Flight Procedures Cover Page	Task Action: FLIGHT CHECK	Task Type: IAP	Estimated Chart Date: 07/09/2026	APWS Task ID: BC740383C20245178E2B8526227DB4E8	APWS Project ID: 35E2F8DDCCDA46549537CD973D4529CC
Procedure: ILS OR LOC RWY 1R AMDT 18	Enroute: NO	Specialist: Sauer, David	Agreement Number:		
Airport ID: KICT	Airport City: WICHITA	State: KS			
Facility ID:	Facility Type:	Flight Inspection Remark Type: New FC Slot

3/13/26: THIS IS AN UPDATED COPY OF THE FORM DEVELOPED ON 12/17/25.

ILS or LOC RWY 1R

WICHITA DWIGHT D EISENHOWER NTL (ICT)

OLD

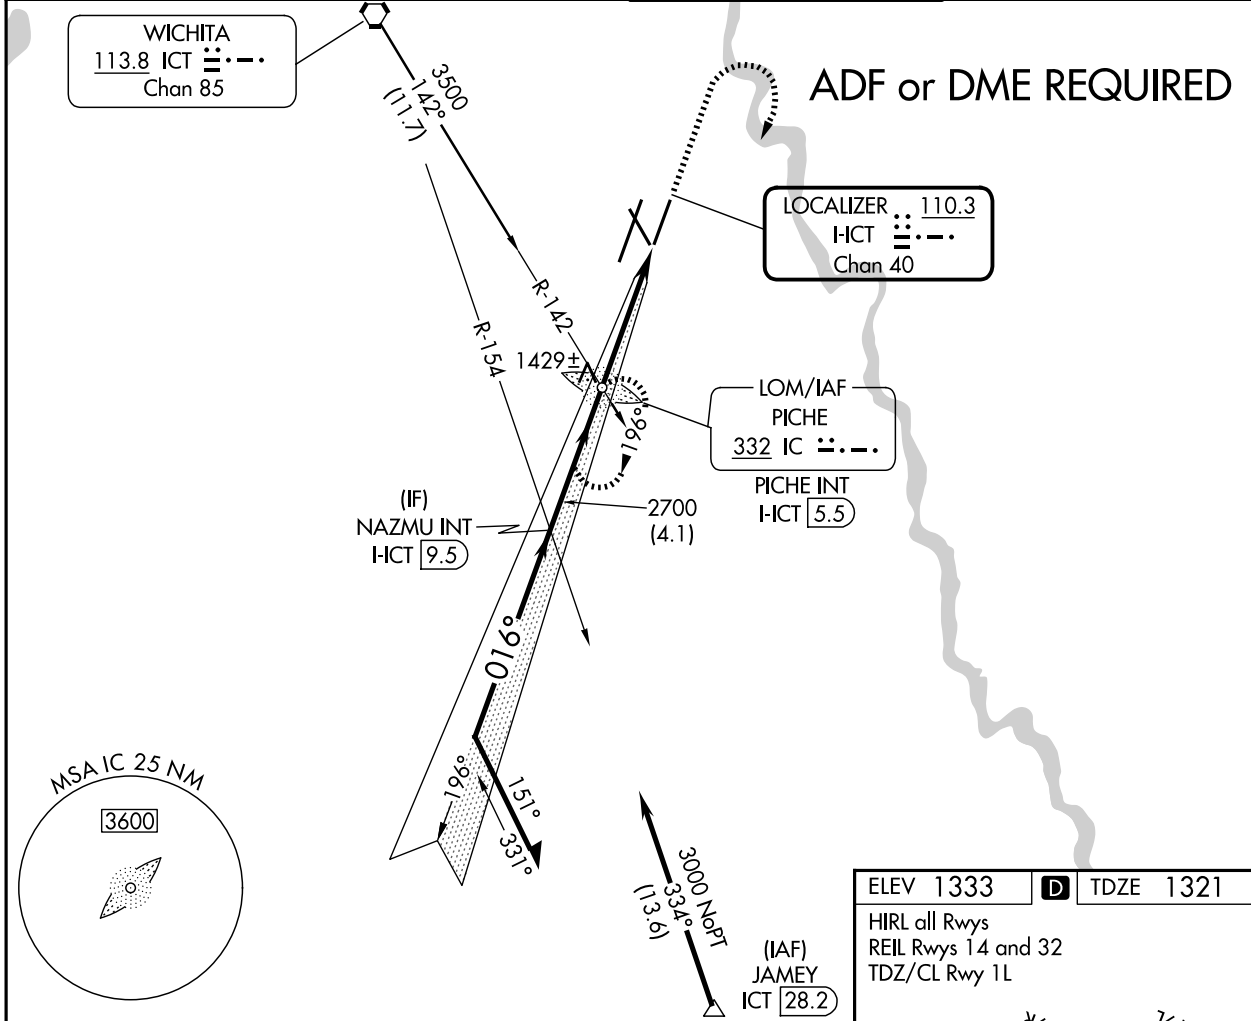
1. Removed dist FAF TO MAP on Line 3 - DME is now Required so no need for timing table.
2. On Line 6, removed "PICHE LOM/I-ICT 5.48 DME" from GS ALT AT PFAF - GS intercept is not at PICHE LOM.
3. Reported: Updated LOC MAP from "4.12 miles after PICHE LOM/I-ICT 5.48 DME or at I-ICT 1.37 DME Fix" to "I-ICT 1.37 DME Fix" - change was previously made, but not captured in changes - reasons.

1. WICHITA VORTAC 8260-2: FIX USE: REMOVED IAP NDB RWY 1R KICT WICHITA KS (US)
